DESIG	n RF	DRAWN BY RF	DART AERO HAWKESBURY,	OSPACE ONTARIO, CANADA	
CHEC	KED 41	APPROVED A	DRAWING NO.		REV. A
	-	A	DSI 9302		SHEET 1 OF 1
DATE		•	TITLE		SCALE
05.0	05.16		STRUT MODIFICATION	KIT	NTS
Α		05.05.16	NEW ISSUE

DART SERVICE INSTRUCTION

TO AMEND INSTALLATION INSTRUCTIONS IIN-D205-633 REV. A

REF. CANADIAN STC: SH96-57 REF. FAA STC: SR00592NY, SR00593NY, SR00594NY

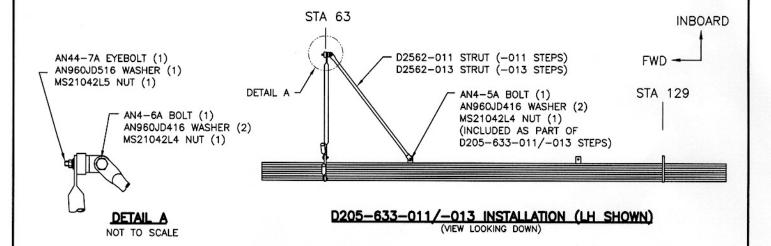
TO MAKE DART D205-633-011/-013 STEPS AT CHG001 COMPATIBLE WITH EQUIPMENT THAT INTERFERES WITH THE INSTALLATION OF THE D2562-001 STRUT (-011 STEPS) OR THE D2562-003 STRUT (-013 STEPS) AT STA 129, IT IS ACCEPTABLE TO INSTALL THE D2562-011 STRUT (-011 STEPS) OR D2562-013 STRUT (-013 STEPS) INSTEAD AS SHOWN BELOW:

FOR D205-633-013 CHG 002 OR LATER, REMOVE (1) D2562-003 STRUT, (1) AN5-6A BOLT, (1) AN4-5A BOLT AND (1) AN960JD516 WASHER AND ADD (1) D2562-013 STRUT, (1) AN44-7A EYEBOLT AND (1) AN4-6A BOLT, SO THAT THE STEP CAN BE INSTALLED AS SHOWN ABOVE.
